CLARENDON COUNTY PROCUREMENT REQUEST FOR PROPOSALS ADDENDUM #4	Solicitation Number	PROJECT: RFP 2024-004 PROVIDE DESIGN/BUILD SERVICES FOR THE CONSTRUCTION OF A NEW PUBLIC WORKS FACILITY AND NEW ANIMAL CONTROL FACILITY. Jeffrey A. Hyde - Procurement Director project@clarendoncountygov.org
---	---	------------------------	---

ADDENDUM #4 -The purpose of this **ADDENDUM** is to revise the Addendum 3 floor finish requirements and address the questions received to date.

NO.	DESCRIPTION	DATE	APPROVED
1	ADDED FIRE HYDRANT SERVICE	8/23/24	[Signature]
2	ADDED CHAIN LINK FENCING	9/16/24	[Signature]

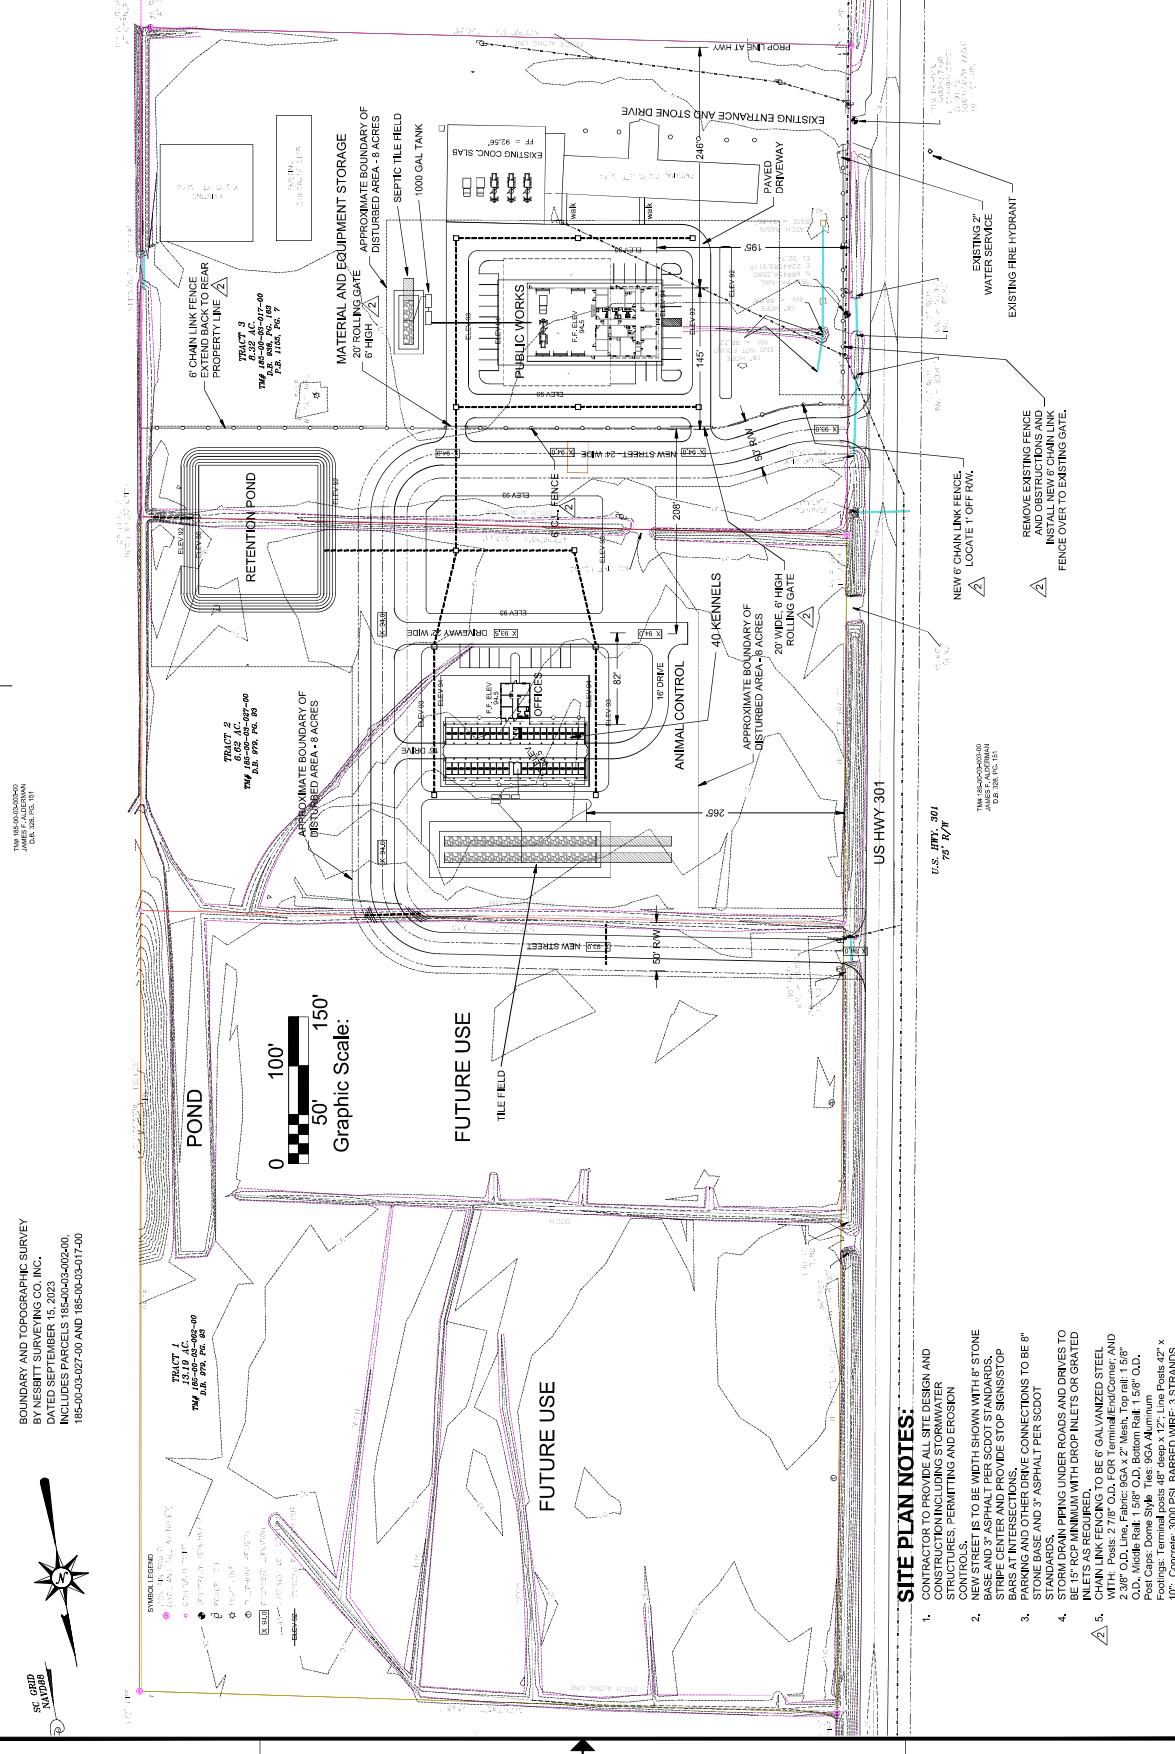
2. **Q:** Access gates are listed in the conceptual specifications but not indicated in the civil drawings. Please provide the desired locations and type of gates. Will the gates be manually operated or automatic and should they tie into the building access control system?
A: See the revised drawing (included) - the gates will be manual rolling gates.

6. **Q:** Please confirm that the intention is to have a hard ceiling in the restroom and washroom of the kennel area.
A: That is correct.
7. **Q:** Water service and fire hydrant locations were added to sheet CS-1. Is this the water main service location for the tap? Will new fire hydrants be required for the site?
A: This is existing 2” water service location. Only if required with fire sprinkler system alternate.
